D/DRC Case

2130 Senate Street

DESIGN/DEVELOPMENT REVIEW COMMISSION
DESIGN REVIEW DISTRICT
CONSENT AGENDA
EVALUATION SHEET
Case # 3

NATURE OF REQUEST: Request Certificate of Design Approval for new construction

Rendering submitted by applicant

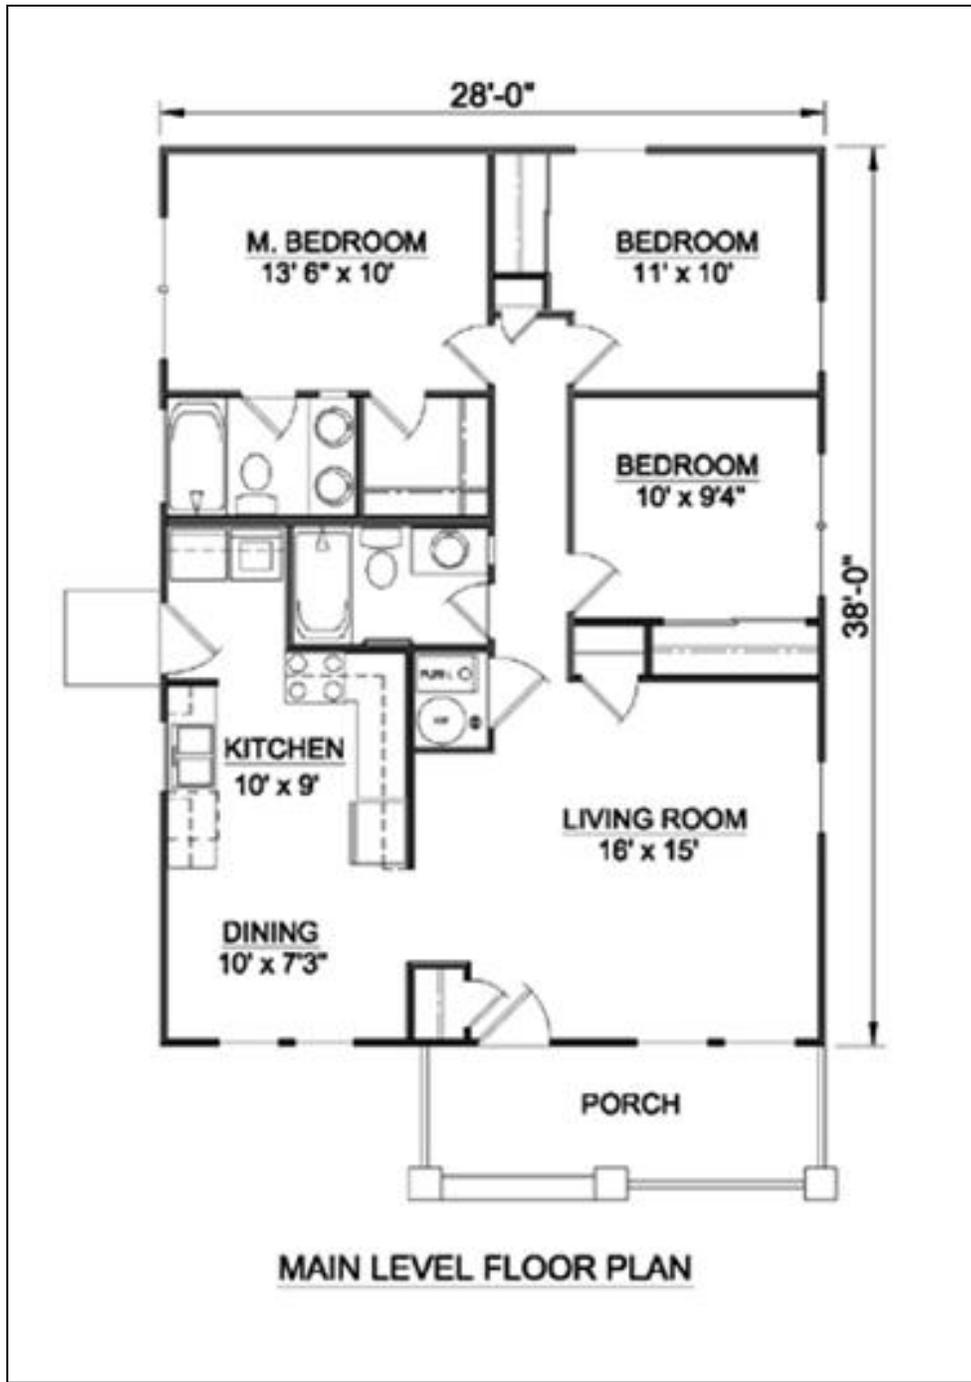
Please note that the proposal varies from the elevations in regards to the roof shape, window configurations and other minor details. Variations from the drawings are mentioned below.

The windows and doors create an acceptable rhythm of openings that are visually compatible with historic buildings nearby on most of the elevations. However, since this is a corner lot the rear elevation will be visible. It has a single window in a span of 28 feet of wall space, it is recommended that another window be added to maintain an acceptable

rhythm of openings; if this is unacceptable for interior spatial arrangement then the window can be walled in from the inside.

The renderings show two side cross gables but the applicant is proposing to eliminate those and have a simple single gable roof. The front gable porch roof will remain as drawn.

Roof Materials: The applicant proposes architectural shingle. While this isn't typical of a historic building of this area, since architectural shingles are meant to replicate a wood shake style, Staff recommends approval due to their minimal visual impact and because of this district's status as a Protection Area. The brackets shown in the roof gables will not be used on the house.

Windows: The proposed windows are 1/1 vinyl double hung sashes. This is different from the drawing, which shows 6/1 windows. Generally the windows are visually compatible with the area. The left side elevation, which will face Pine Street, has two sets of smaller windows, which are above a bathtub and a kitchen sink. When the grids are removed from these windows their unusual size will probably be even more obvious. It is recommended that the kitchen window be changed from what appears to be a sliding or casement window to a 1/1 sash window.

Door: The applicant is not proposing the door shown in the rendering, and Staff is happy to work with the applicant on a door appropriate to the house, including a solid panel door, a Craftsman-influenced door, etc.

Porch: There are three porch posts with battered wood columns on brick pedestals. Brick will be used instead of the stone shown in the attached rendering. Craftsman style homes on this street often feature this style. The brackets shown on the plans in the gable will not be used on this building. The doubled cornice board is a good trim detail, and the typical

- Door design and materials to be approved by Staff
- Kitchen window to be changed to a 1/1 sash window
- An additional window be placed on the rear of the house to maintain an acceptable rhythm of openings
- Any changes to original site plan (besides house measurements) to be submitted to and approved by Staff
- All details deferred to Staff

PREVIOUS site plan submitted by applicant. Please note that the driveway has not been included and that the new house is four feet narrower and six feet longer.

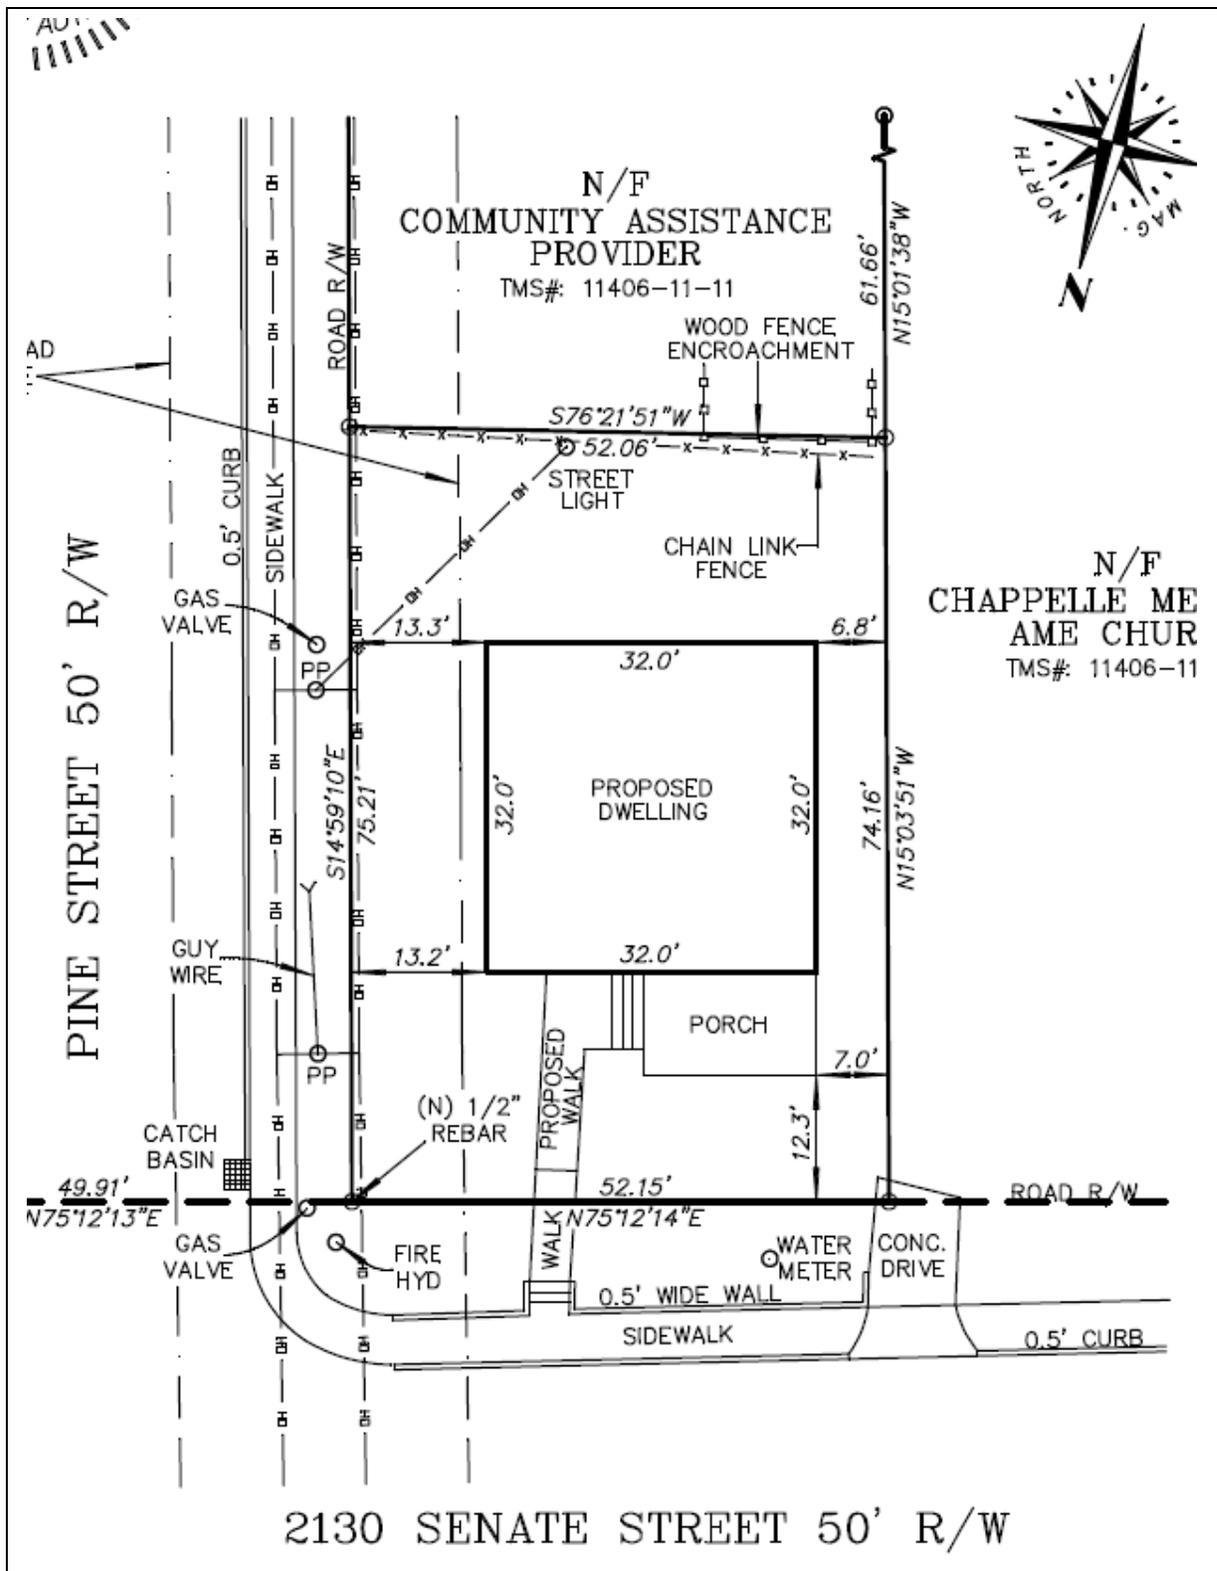
The applicant proposes the same setback as originally proposed, of approximately 20' from the front sidewalk on Senate and about 18' from the sidewalk along Pine Street. The average of setbacks on Pine Street from the approximate sidewalk location is about 24 feet. On Senate Street's 2200 block the residential buildings range from about 10' to 30' setbacks. Therefore, the location of this building will be similar to the average setbacks, even though the setback of adjacent structures varies widely.

The current city ordinance allows for 12' wide driveways in historic districts. Approved materials for protection areas include concrete, which is the proposed material for the driveway. The driveway will extend into the yard at the rear of the house, off of a curb cut that already exists on Pine Street.
